**INTERNATIONAL ATOMIC ENERGY AGENCY**

**EXPERTS MISSION TO REVIEW  
THE PSAR OF THE RRR  
FOR ARPANSA**

**FINAL REPORT, 10 July 2001**

**Australian Radiation Protection and Nuclear Safety Agency**

**Figure 1 – Comparison between design value and disaggregated IGNS value.**

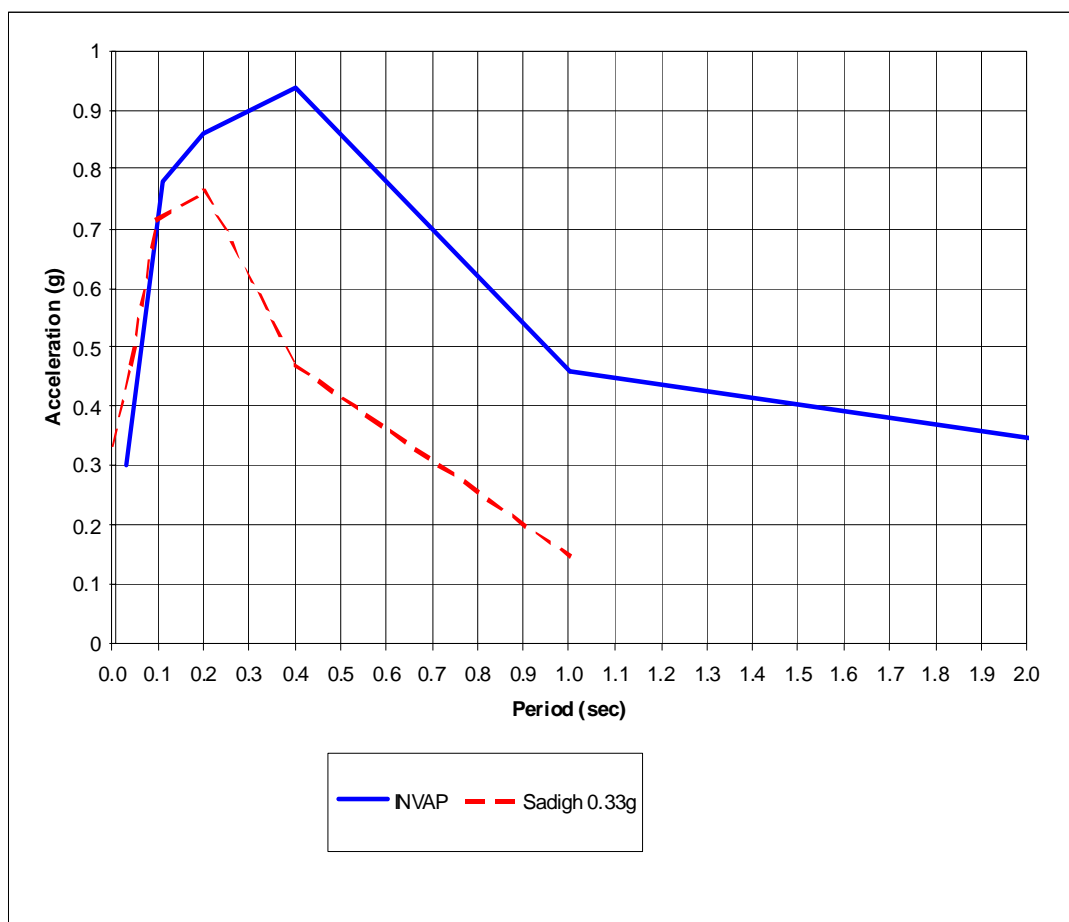
- The assumption that the adopted (standard) response spectrum anchored to 0.3g envelopes the site specific response spectrum anchored to 0.41g is not valid for all frequency ranges of interest. The rock site transmits high frequencies and according to INVAP calculations all the components analysed within the pool have a frequency in excess of 7 Hertz. Even the reactor building itself has a natural frequency close to 7 Hz.

In addition, the comparison of the 0.3g pga with the Carbon Canyon spectrum with the disaggregated East Sydney controlling earthquake of 0.33g, as in Figure 1 below, shows that the design value effectively bounds this recommended value from IGNS.
